Our Reference: NSW201629

Re: Northside West Clinic, 23-27 Lytton Street, Wentworthville – Response to SES letter

This letter is prepared in response to the comments made by SES in their letter dated 12 September 2021.

**FIGURE
C8**

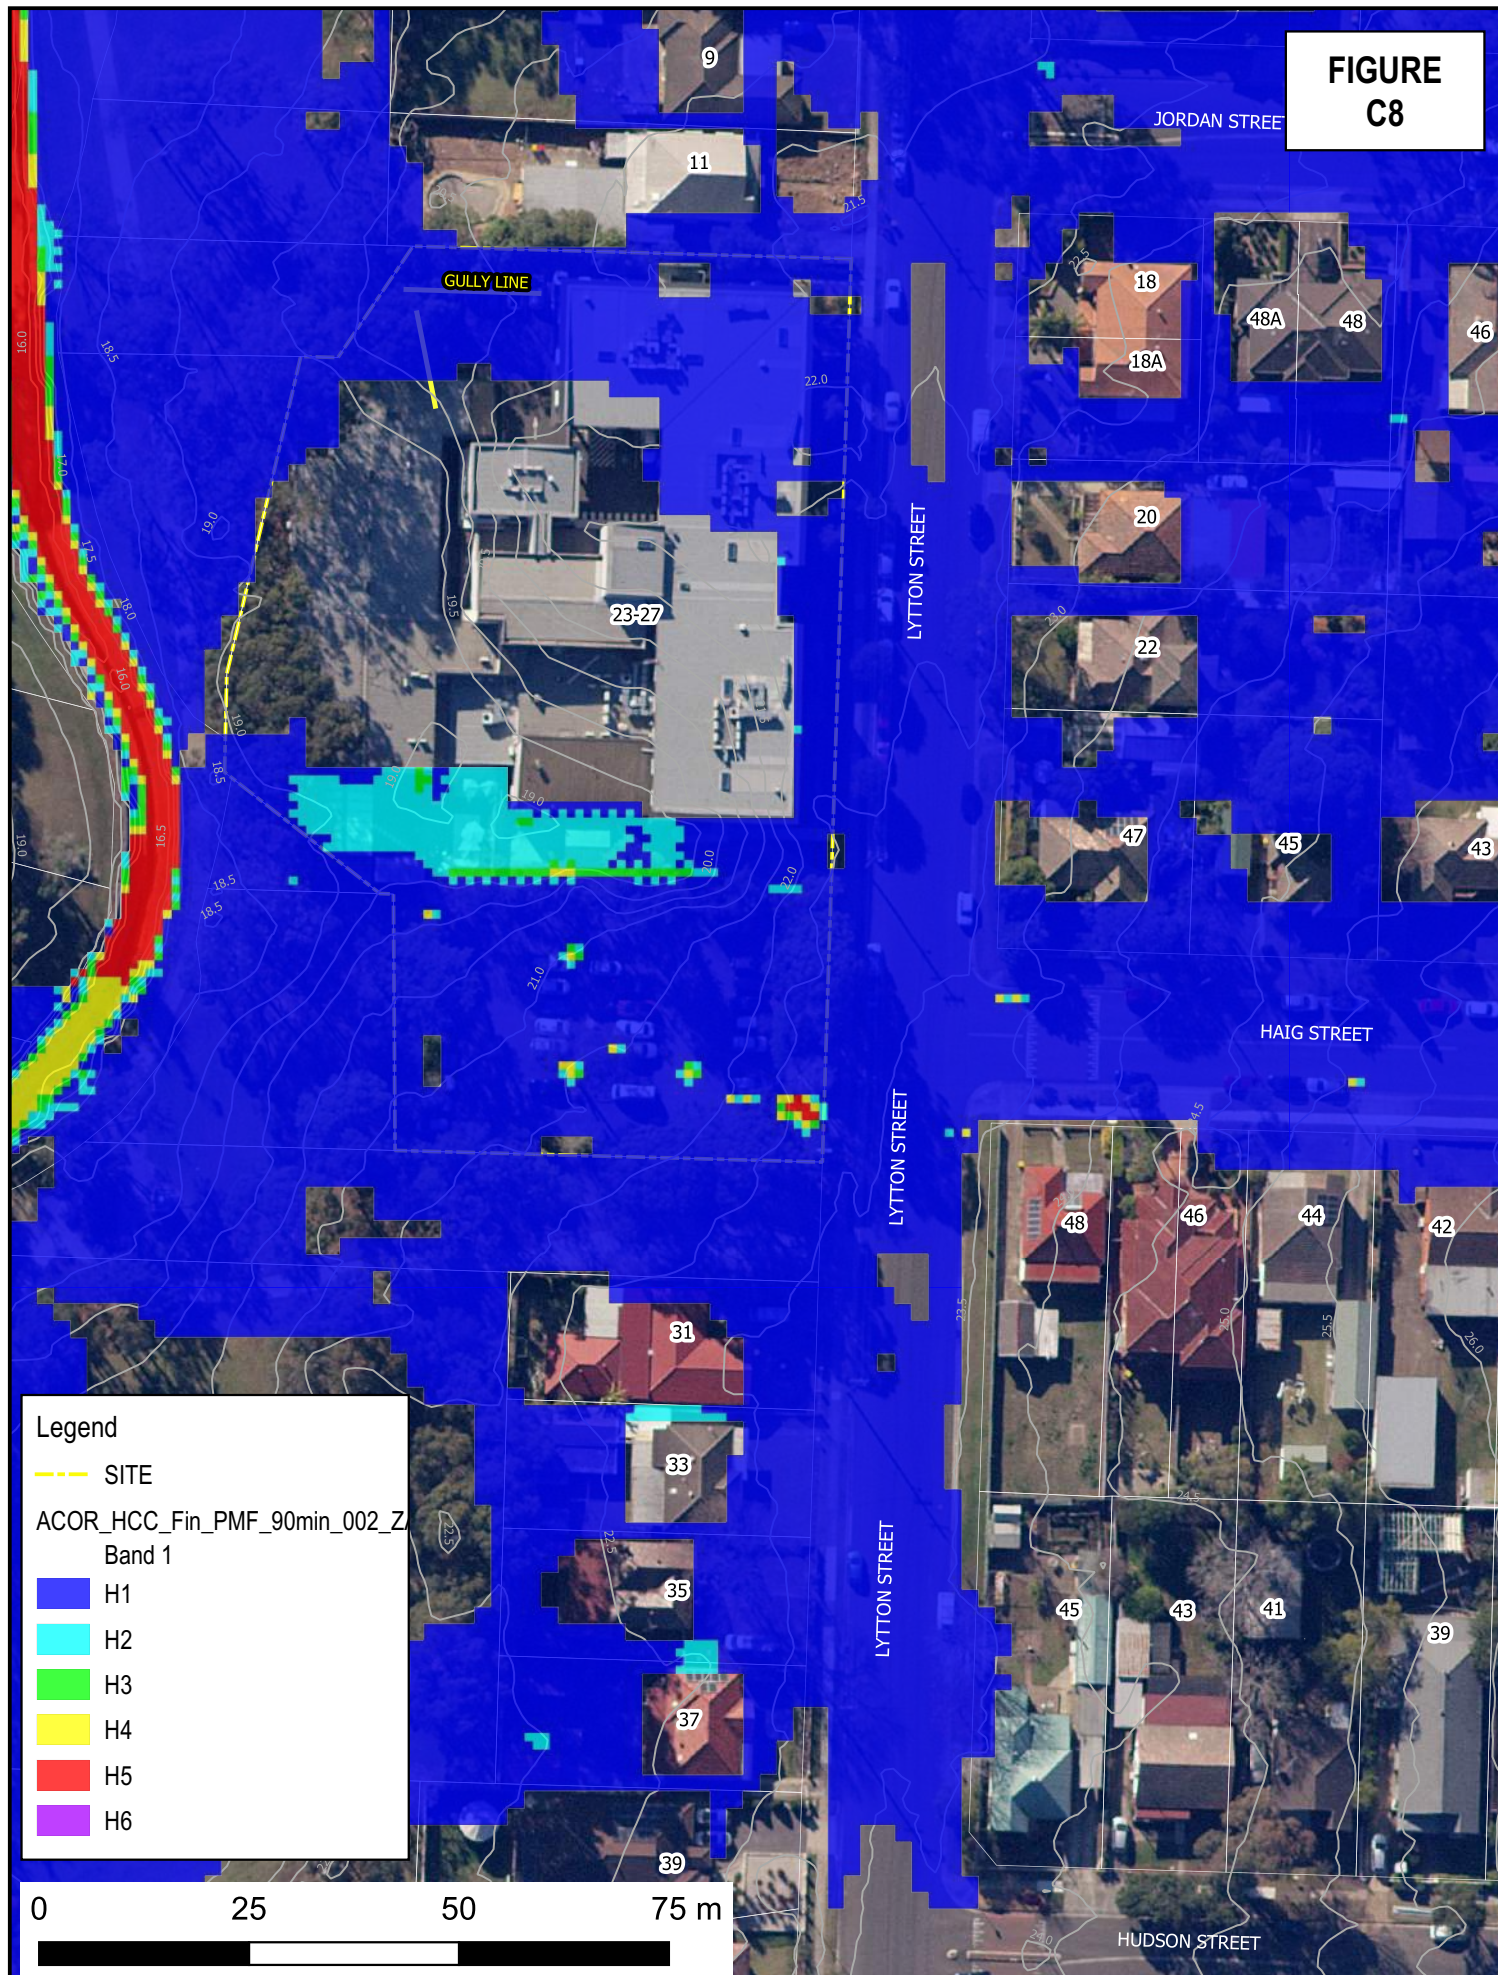
Flood hazard analyses were carried out during the PMF events during both the pre-developed (existing) and the post-developed (proposed) scenario in accordance with the Australian Disaster Resilience Guideline 7-3 Flood Hazard (AIDR 2017). Refer to the attached map showing the PMF flood hazard.

The post-development flood hazard exposure within the site generally remains consistent with the existing scenario. The associated flood hazard within the northern carpark area can be classified within the H1 category, which is considered generally safe for vehicles, people and buildings.

The existing driveway to the south of the building, which is mainly used by service vehicles and has no associated permanent carparking facilities, would be exposed to H2 to H3 category of flooding. The H2 category is classified as unsafe for small vehicles, while H3 is classified as unsafe for vehicles, children, and the elderly. The flood hazard category does not change during the post-developed scenario as no modification to the existing driveway has been proposed.

The existing driveway near the south-eastern corner of the site that led to the existing open carpark area experiences a hazard up to the H4 category during the pre-developed (existing) scenario, which is rendered unsafe for vehicles and people. However, the high hazard area is confined within the existing driveway area, which was anticipated to have higher velocity due to a slope of approximately 7.8%. The hazard classification remains consistent during the post-developed scenario. A flood hazard category up to H5 (rendering unsafe for vehicles and people) was noticeable during the post-developed scenario within the proposed landscaping at the southwest corner of the site. As a flood risk management strategy, the landscaping area and the driveway entrance to the southern carpark will be sign-posted with flood warning signs shown below in Figure 1.
